TITLE  
 PCB, CTRL, CC-16, AC2DC,  
 S12MS, NOI, SC, NCTL

DWG NO. 09270126 REV 7

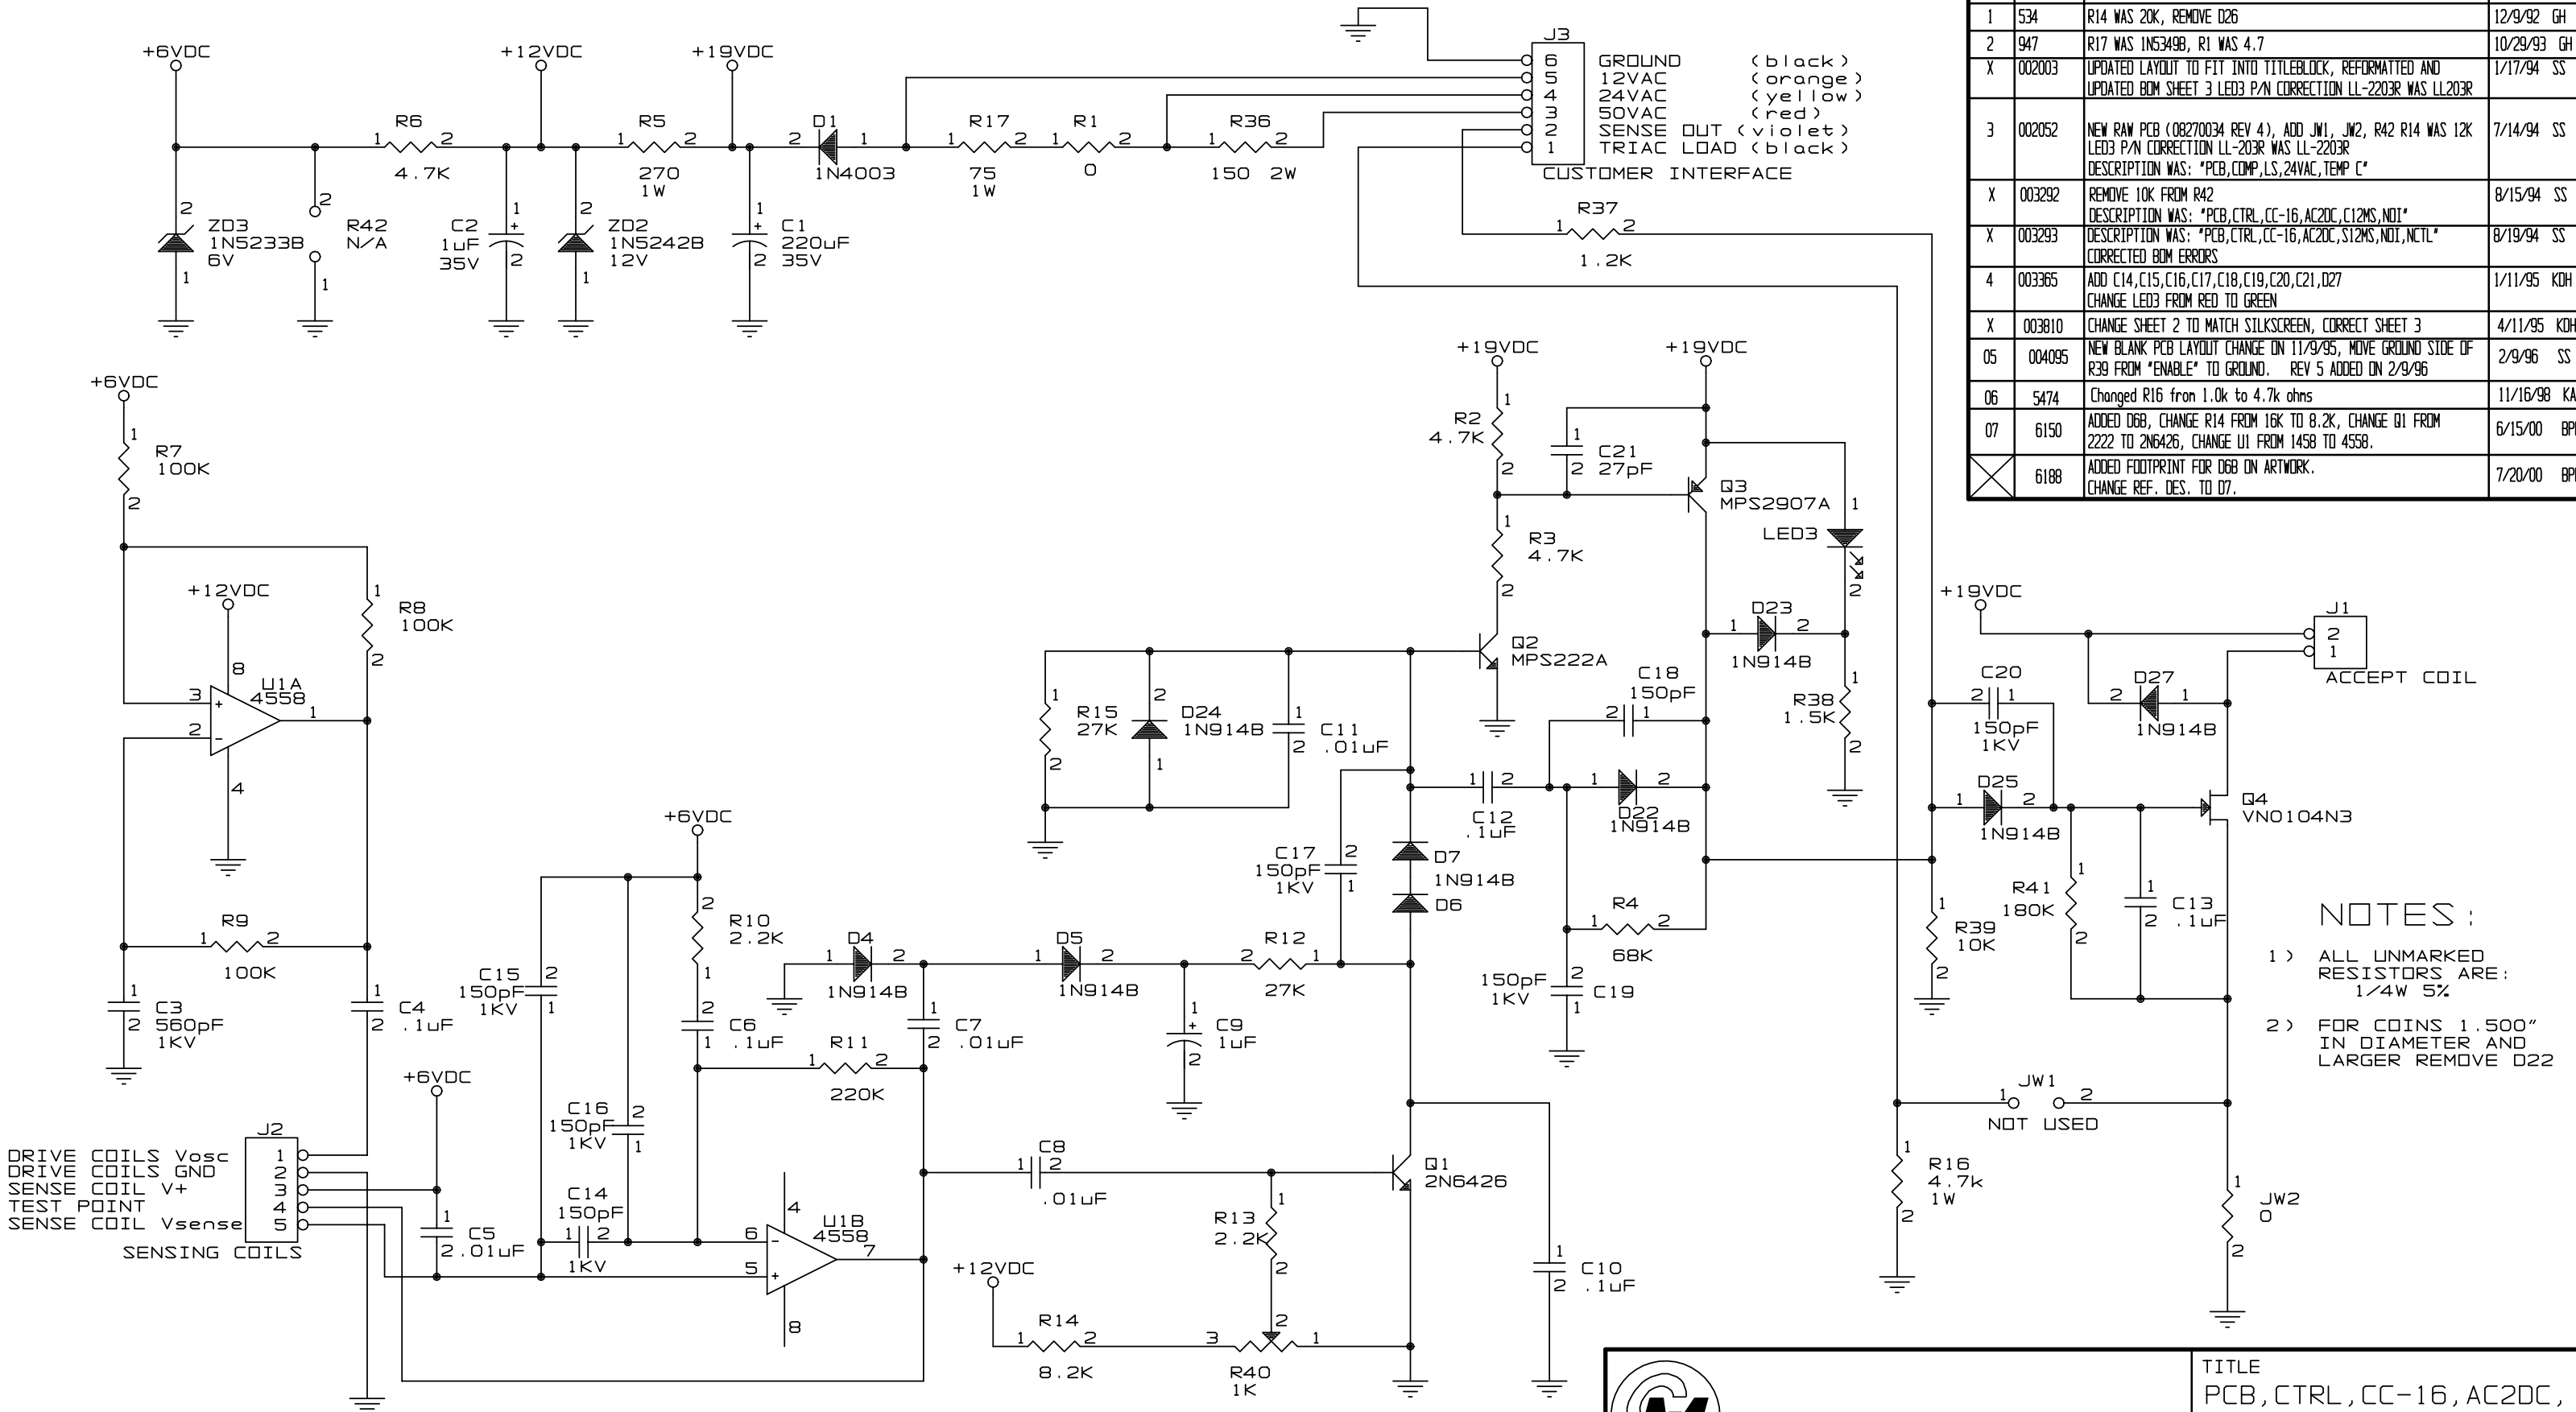
NO.	ECO NO.	REVISIONS	DATE/BY
0	X	RELEASED	4/24/92 SS
1	534	R14 WAS 20K, REMOVE D26	12/9/92 GH
2	947	R17 WAS 1N5349B, R1 WAS 4.7	10/29/93 GH
X	002003	UPDATED LAYOUT TO FIT INTO TITLEBLOCK, REFORMATTED AND UPDATED BOM SHEET 3 LED3 P/N CORRECTION LL-2203R WAS LL203R	1/17/94 SS
3	002052	NEW RAW PCB (08270034 REV 4), ADD JW1, JW2, R42 R14 WAS 12K LED3 P/N CORRECTION LL-2203R WAS LL-2203R DESCRIPTION WAS: "PCB,COMP,LS,24VAC,TEMP C"	7/14/94 SS
X	003292	REMOVE 10K FROM R42 DESCRIPTION WAS: "PCB,CTRL,CC-16,AC2DC,C12MS,NOI"	8/15/94 SS
X	003293	DESCRIPTION WAS: "PCB,CTRL,CC-16,AC2DC,S12MS,NOI,NCTL" CORRECTED BOM ERRORS	8/19/94 SS
4	003365	ADD C14,C15,C16,C17,C18,C19,C20,C21,D27 CHANGE LED3 FROM RED TO GREEN	1/11/95 KOH
X	003810	CHANGE SHEET 2 TO MATCH SILKSCREEN, CORRECT SHEET 3	4/11/95 KOH
05	004095	NEW BLANK PCB LAYOUT CHANGE ON 11/9/95, MOVE GROUND SIDE OF R39 FROM "ENABLE" TO GROUND. REV 5 ADDED ON 2/9/96	2/9/96 SS

06	5474	Changed R16 from 1.0k to 4.7k ohms	11/16/98 KAR
07	6150	ADDED D6B, CHANGE R14 FROM 16K TO 8.2K, CHANGE Q1 FROM 2222 TO 2N6426, CHANGE U1 FROM 1458 TO 4558.	6/15/00 BPP
X	6188	ADDED FOOTPRINT FOR D6B ON ARTWORK. CHANGE REF. DES. TO D7.	7/20/00 BPP
